EO1-79K39135

Revitalize Medium Voltage Electrical Distribution Systems, Industrial and Payload Processing Areas

# ENGINEERING ORDER

6. Reason for Change
1) Resolve existing field condition and safety issue, wherein existing parking lot lighting circuits were installed without equipment ground conductors.
2) Provide for the medium-voltage electrical power infrastructure to serve proposed new Data Center.

## DEMOLITION PLAN – AREA D (2)

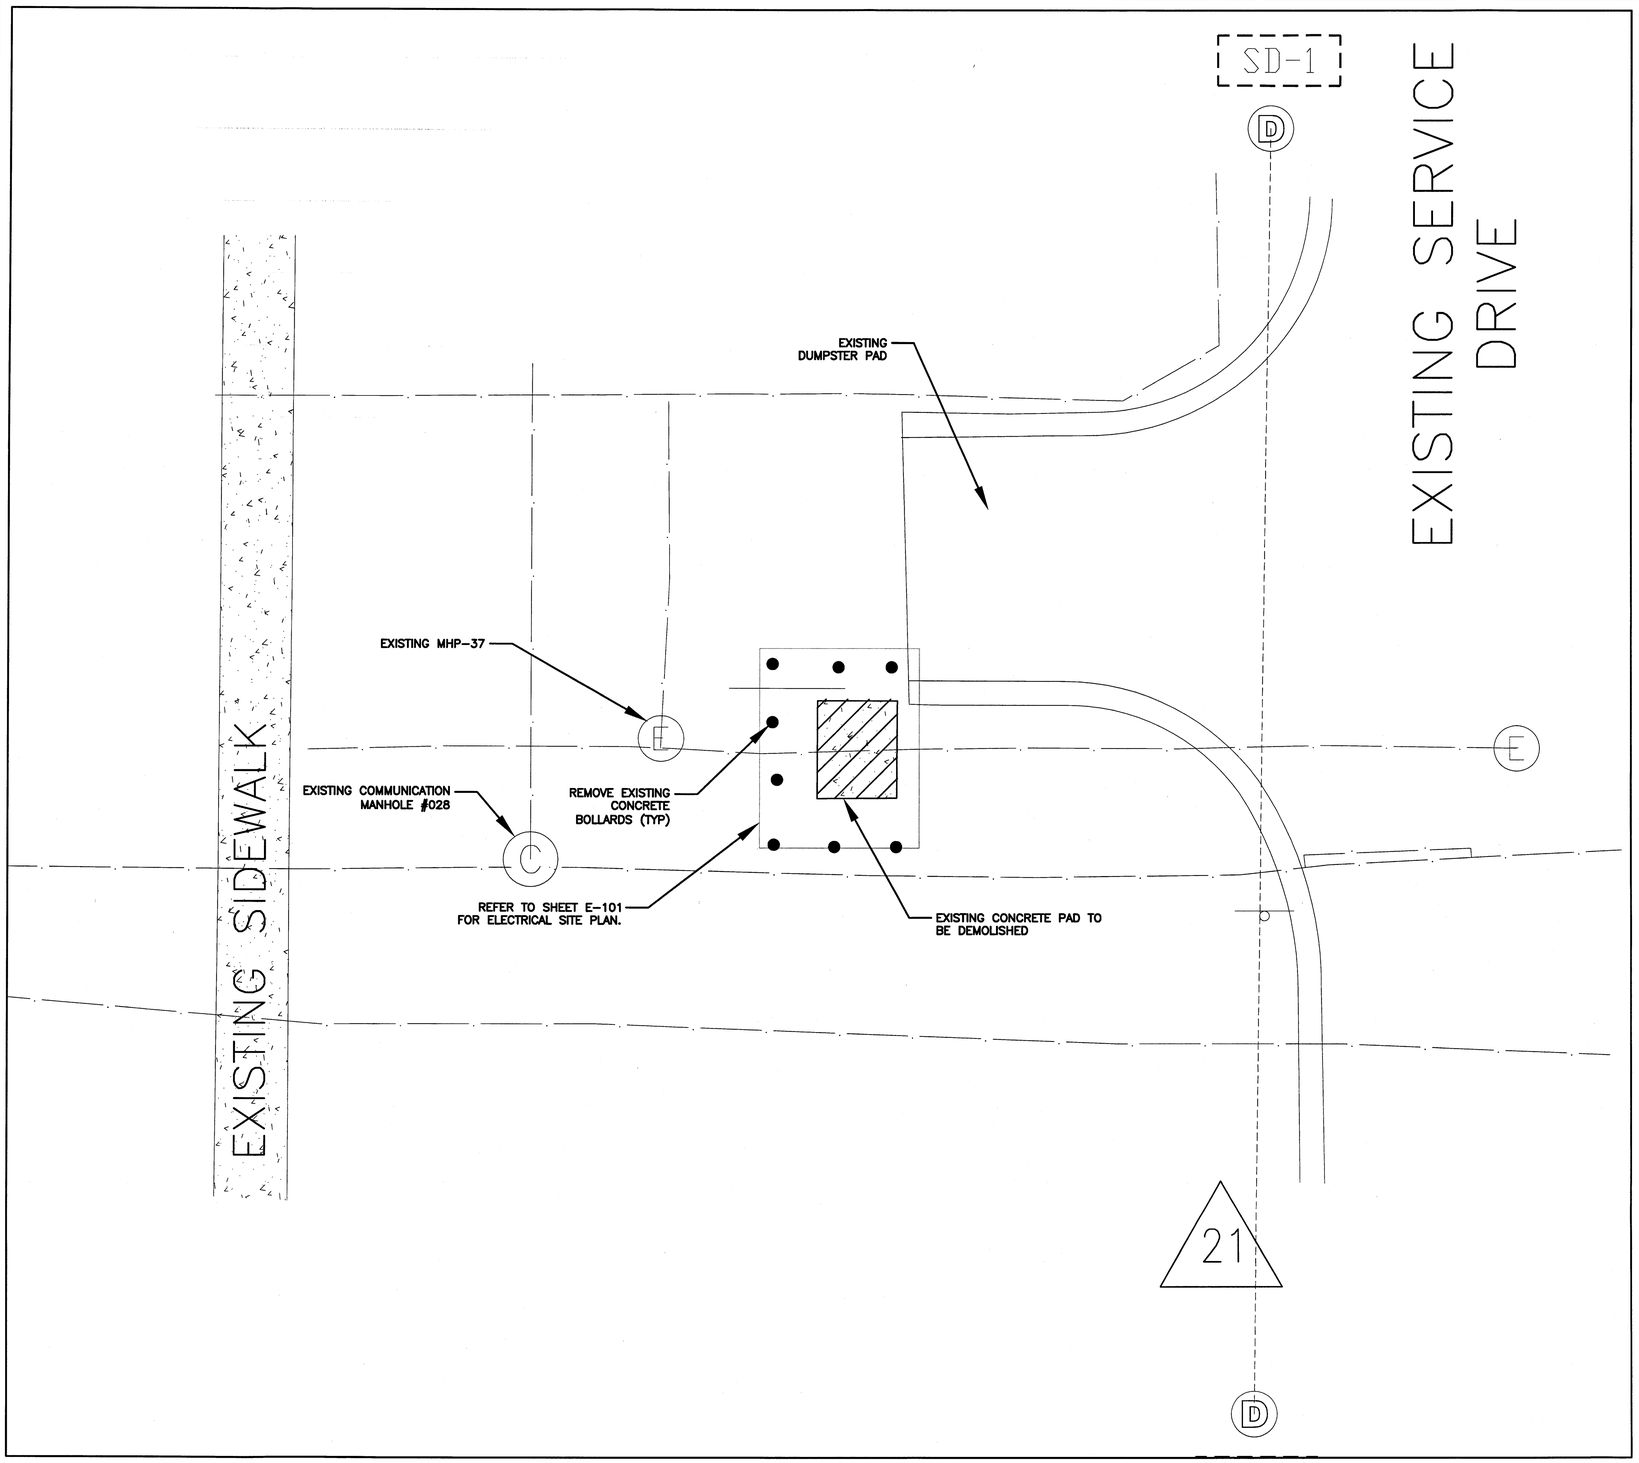
1) Drawing 79K39135 sheets 11, 35, 36, 38, 39, 45, 46, 47, 72, 74, 76, 78, 79 were edited and additional drawings C-108, C-403, E-408, and E-605 were created to show the addition of two VFI switches, ductbank routing and sections, two manholes, demolition and replacement of conductors for the proposed Data Center.

## ENLARGED PLAN WEST O&C (M7-355) PARKING LOT LIGHTING – MODIFIED (1 / E-102)

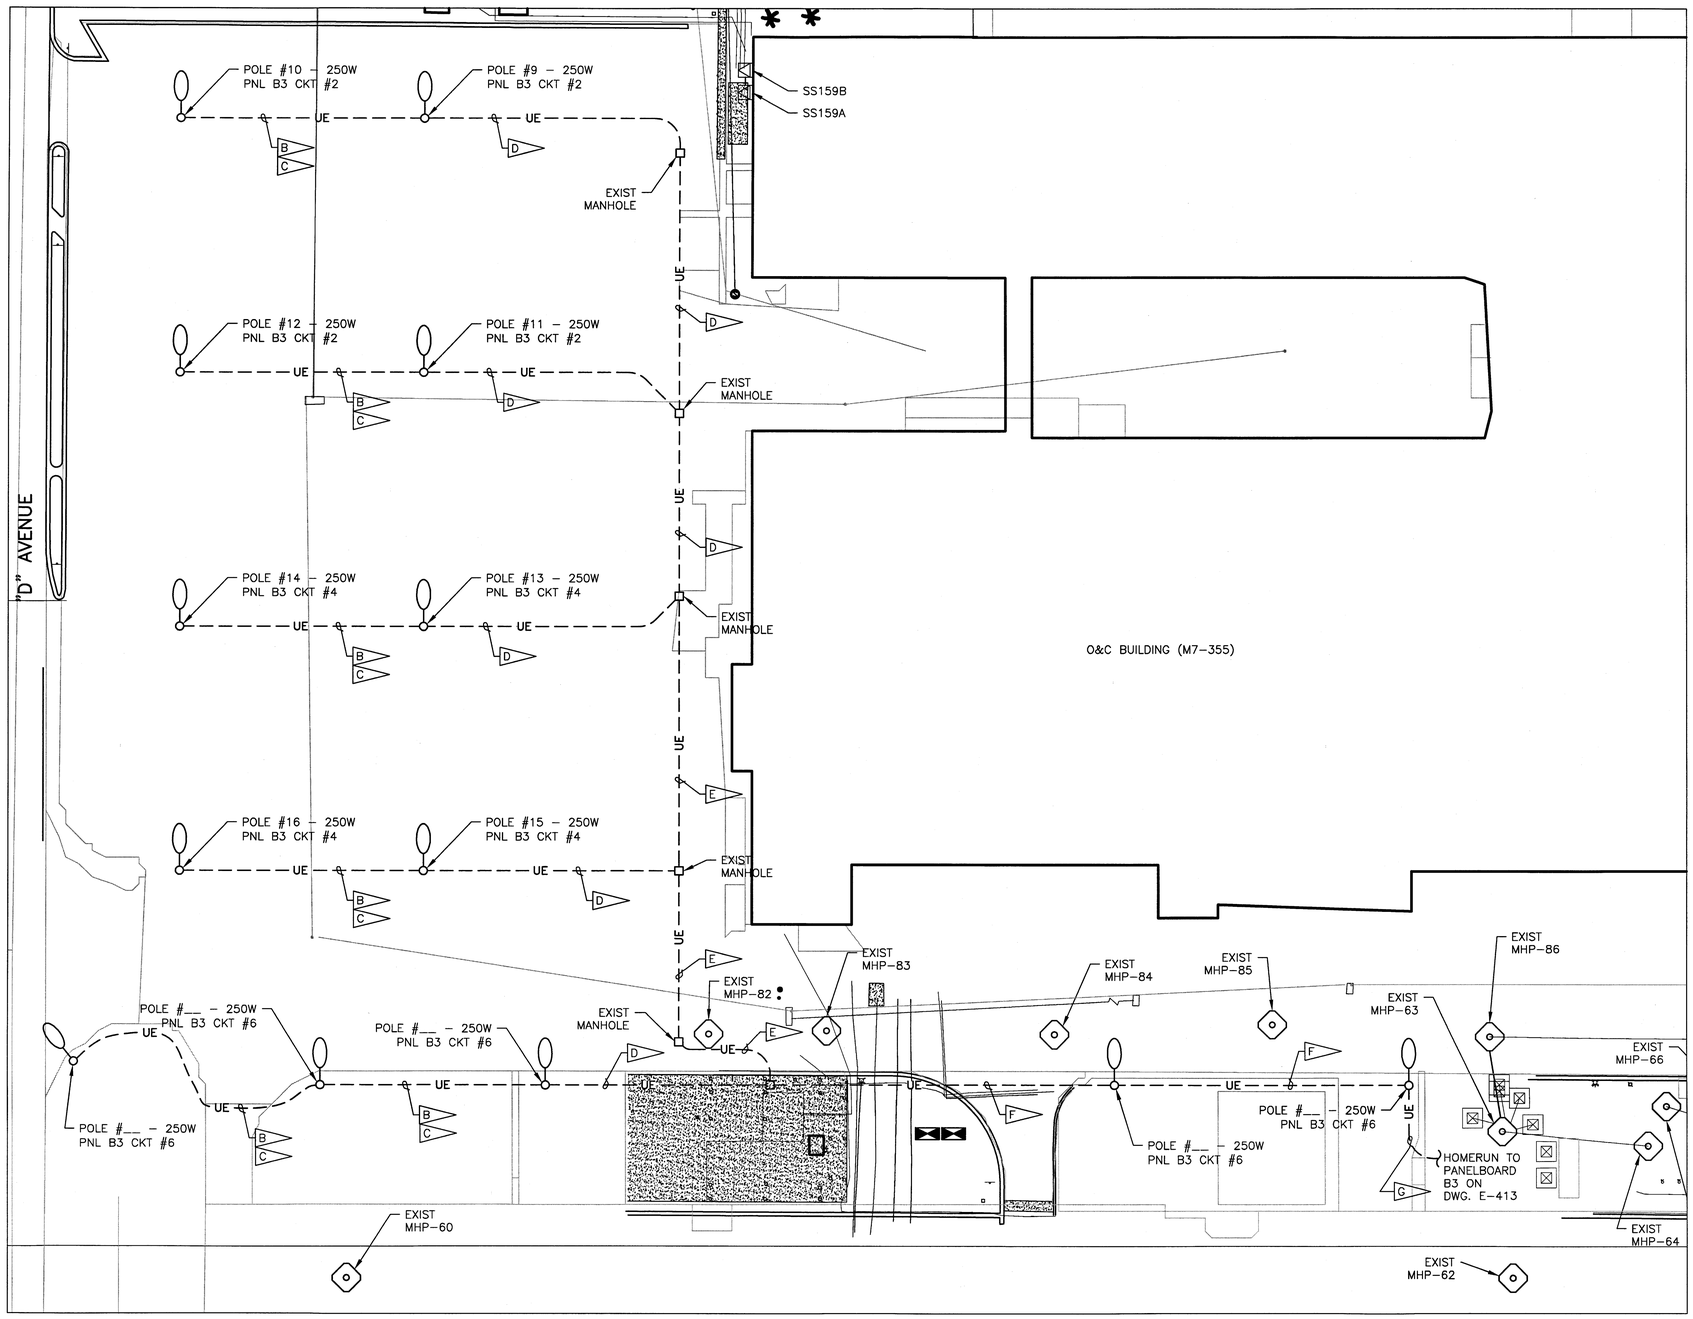
2) Drawing 79K39135 sheet 55 was edited and additional drawings E-441 and E-442 were created to show the addition of the NEC compliant equipment grounding conductors for O&C Bldg. (M7-355) parking lot light poles.
